APPLICATION NO.	FILING DATE	FIRST NAMED INVENTOR	ATTORNEY DOCKET NO.	CONFIRMATION NO.
10/817,452	04/02/2004	Roger Minkow	019053.000112	1612
27644	7590	09/14/2005	EXAMINER	
THOMPSON & KNIGHT L.L.P. PATENT PROSECUTION DEPARTMENT 98 SAN JACINTO BLVD., SUITE 1900 AUSTIN, TX 78701			LUONG, VINH	
		ART UNIT		PAPER NUMBER
				3682

Office Action Summary

Application No. 10/817,452	Applicant(s) MINKOW ET AL.
Examiner Vinh T. Luong	Art Unit 3682

FIG. 6

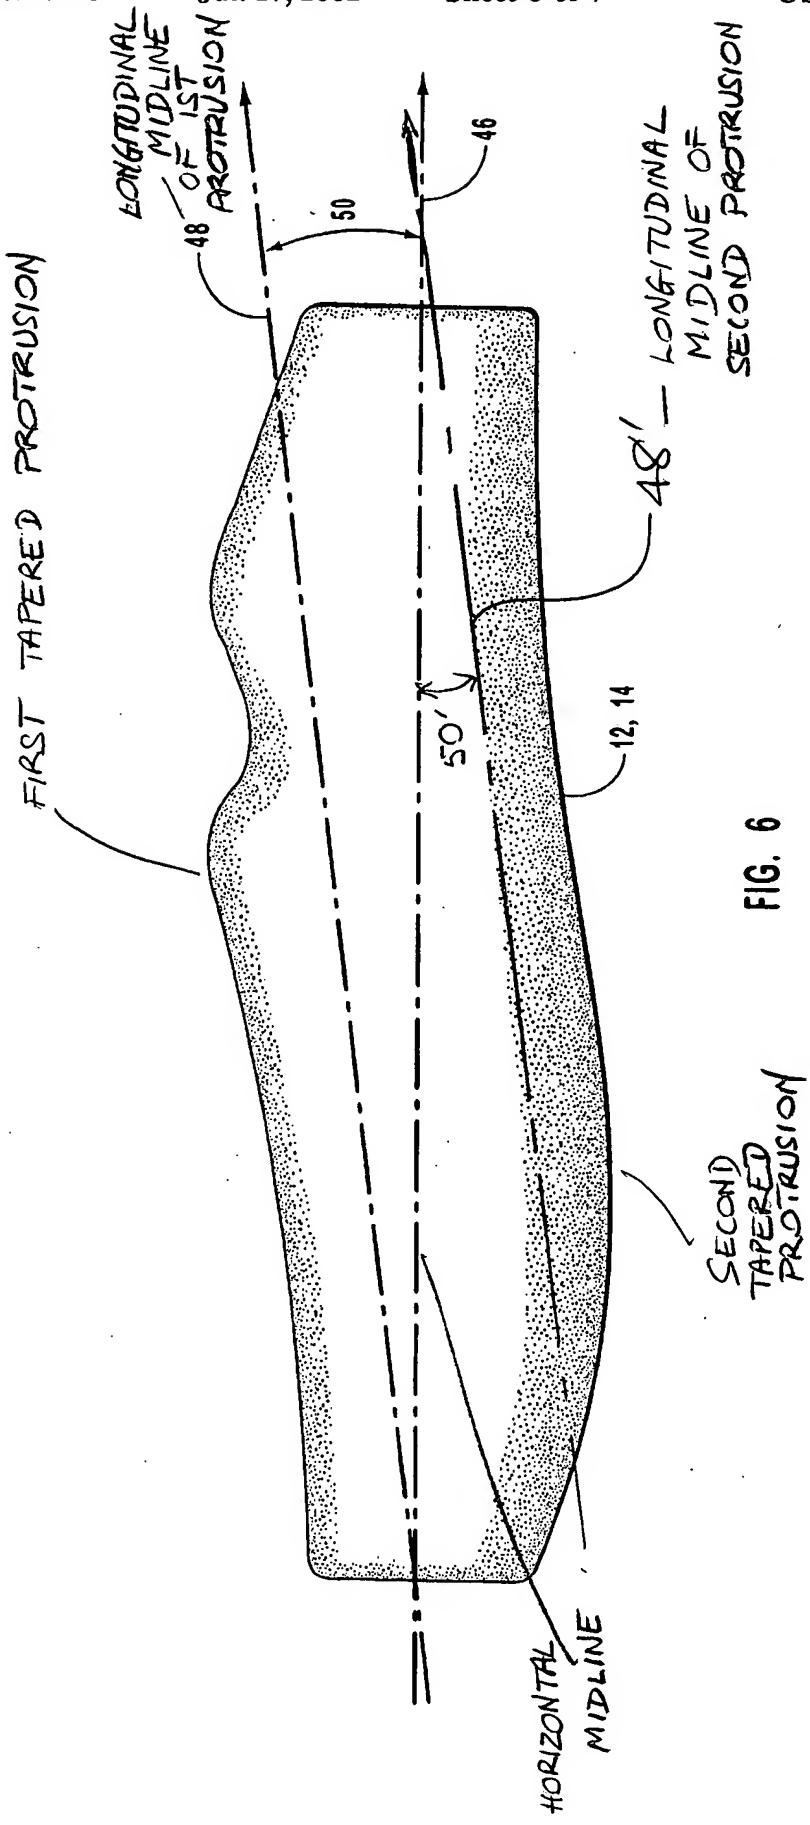
a first tapered protrusion 28 disposed on a forward side of the generally tubular body, on which a person's fingers can rest, the forward side generally longitudinally bisected by the horizontal midline 46 (see Attachment); and

a second tapered protrusion 26 disposed on a rear side of the generally tubular body, on which the person's palm can rest, the rear side generally longitudinally bisected by the horizontal midline 46 (Att.);

wherein the first tapered protrusion 28 has a first longitudinal midline 48 (Att.) extending between first and second ends of the first tapered protrusion, the longitudinal midline rotated at an angle 50 to the horizontal midline 46 of the generally tubular body;

wherein the second tapered protrusion 26 has a second longitudinal midline (Att.) extending between first and second ends of the second tapered protrusion 26, the second longitudinal midline (Att.) rotated at an angle to the horizontal midline 46 of the generally tubular body and disposed *generally parallel* to the first longitudinal midline (Att.) of the first tapered protrusion 28; and

In addition, contrary to Applicant’s remarks, the kayak paddle of the Heap reference, generally shown in Figures 1 and 1A includes raised protrusions 28 and 26 as enlarged in Figs. 3 and 6. Each protrusion has a longitudinal axis (Att.) generally angled with the longitudinal axis 46 of paddle shaft 16. In other words, either the longitudinal axis of protrusion 28 or protrusion 26 is rotated with respect to the longitudinal axis 46 of paddle shaft 16.

The Examiner also notes that the angle 50 shown in Figure 6 of the Heap reference generally shows the vertical height or thickness of the given grip 12 or 14 and the rotation when the operator rotates the paddle.
